STATE OF RHODE ISLAND & PROVIDENCE PLANTATIONS  
EXECUTIVE CHAMBER  
PROVIDENCE

Enclosed are copies of our technical reviews of the Draft  
Environmental Statement on NEP 1 and 2.

REVIEW OF SECTIONS  
of  
Draft Environmental Statement  
dealing with  
Hydrology

Review of Sections of NUREG-0529  
Draft Environmental Statement  
related to construction of  
New England Power Units 1 and 2 (NEP 1+2)

FIG. 7 COMPARISON OF CHARLESTOWN QUONSET POINT, & GREENE AIRPORT DATA

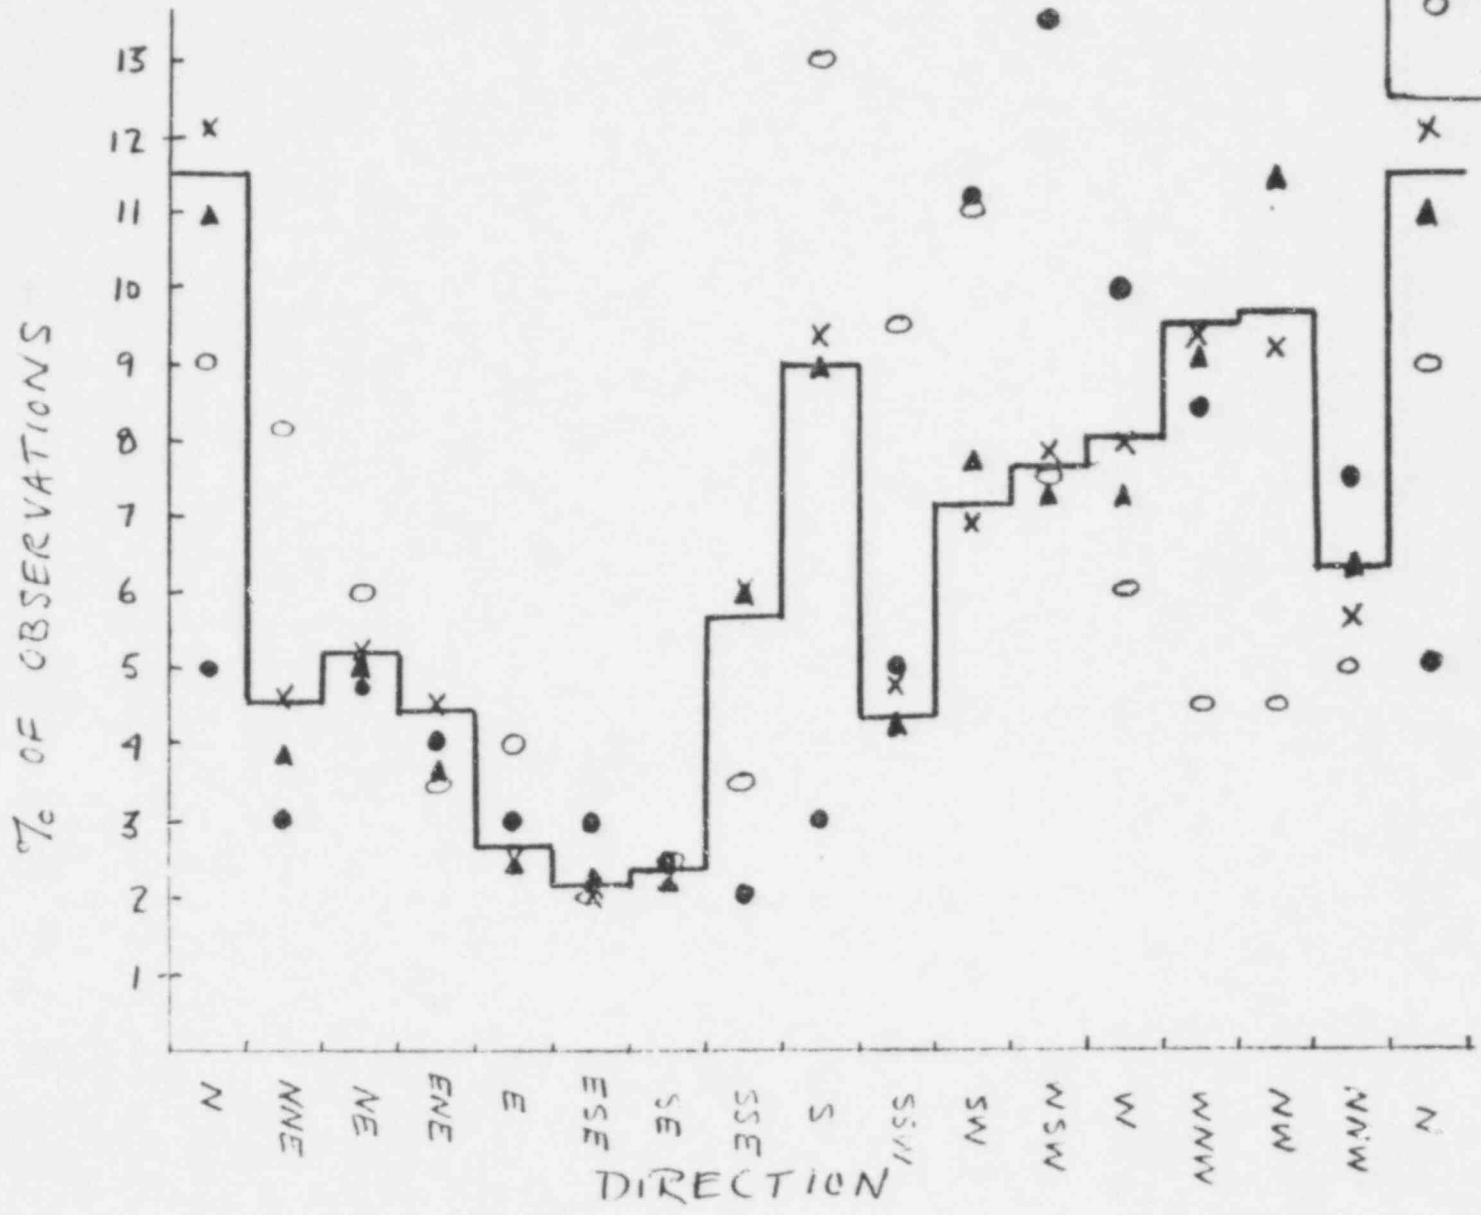
After a review of the Quonset Point Naval Air Station data, it appears that the information contains serious local effects or the wind rose shown in Fig. 9.9 is not correct. Figure 7 shows a comparison between the % observation of wind for a given direction between the Quonset data (9 year record) and a 5 year record taken at Greene Airport. Also shown are typical yearly data for the Greene Airport station indicating the year to year variation. It is clear from this comparison that while the winds at Quonset are dominated by the N, NNE, NE, and SW, SSW, S, the winds at Greene (approximately 5 km to the north) show considerably more winds from the NW quadrant. The Greene Airport station is also more typical
